CITY OF ALBUQUERQUE

Planning Department
Alan Varela, Director

Re: San Mateo Manor
513 Ortiz Dr. SE Albuquerque, NM 87108
Traffic Circulation Layout
Engineer's Stamp 10-16-25 (L18-D088)

FIGURE 7.4.115 Bicycle Parking Stall Layout Options

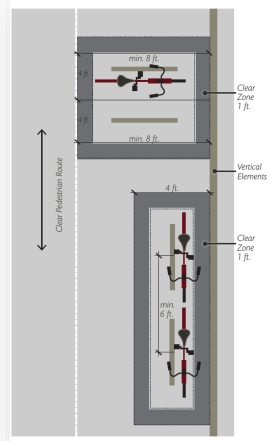
23. Bicycle parking spaces shall be located, sized, and constructed as required by IDO.
24. Provide bicycle parking design. Bicycle racks shall be designed according to the following guidelines:
 - The rack shall be a minimum 30 inches tall and 18 inches wide.
 - The bicycle frame shall be supported horizontally at two or more places. Comb/toaster racks are not allowed.
 - The rack shall be designed to support the bicycle in an upright position. See the IDO for additional information.
 - The rack allows varying bicycle frame sizes and styles to be attached.
 - The user is not required to lift the bicycle onto the bicycle rack.
 - Each bicycle parking space is accessible without moving another bicycle.
25. Bicycle racks shall be sturdy and anchored to a concrete pad.
26. A 1-foot clear zone around the bicycle parking stall shall be provided.

27. Bicycle parking spaces shall be at least 6 feet long and 2 feet wide.
